MIL-M-28787/51B(SH)
AMENDMENT 1
19 July 1991

MODULES, STANDARD ELECTRONIC

RECEIVER, TRANSLATE, DIGITAL, KEY CODE MDQ

FIGURE 8. Logic load circuit.

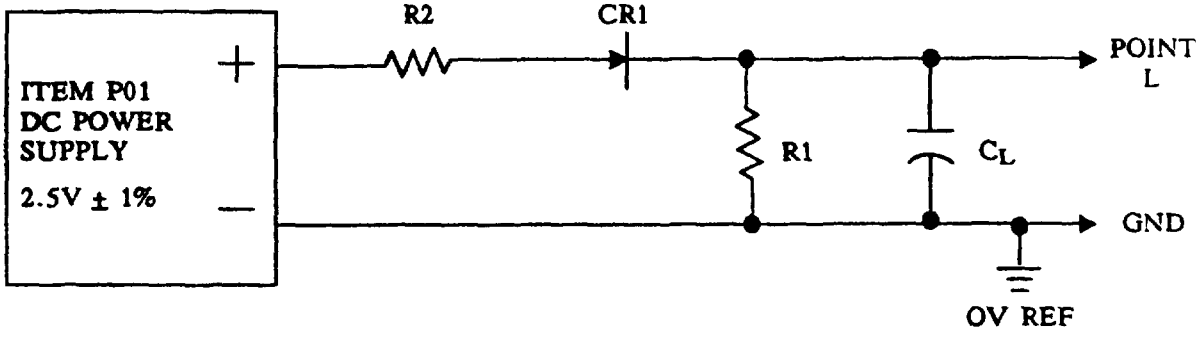
FIGURE 8. Delete and substitute new figure 8 as printed on page 3 of this amendment

NOTES:
1. R1 = Select value for a current flow of 0.1mA ± 1% into point L when L is held at 2.4Vdc.
2. R2 = Select value for a current flow of 1.6mA ± 1% when point L is held at 0.4V.
3. C_L = 50 ± 3pF (including probe and parasitic capacitance).
4. CR1 = 1N4150, or equivalent.
5. C_L is not required for dc electrical tests C1-C4, D1-D4, E1-E12, and F1-F8.
6. The maximum lead length from point L to the appropriate module pin shall be 3 inches (76.2mm).
7. During output switching, the 2.5V power supply shall have a maximum overshoot of 500mV.
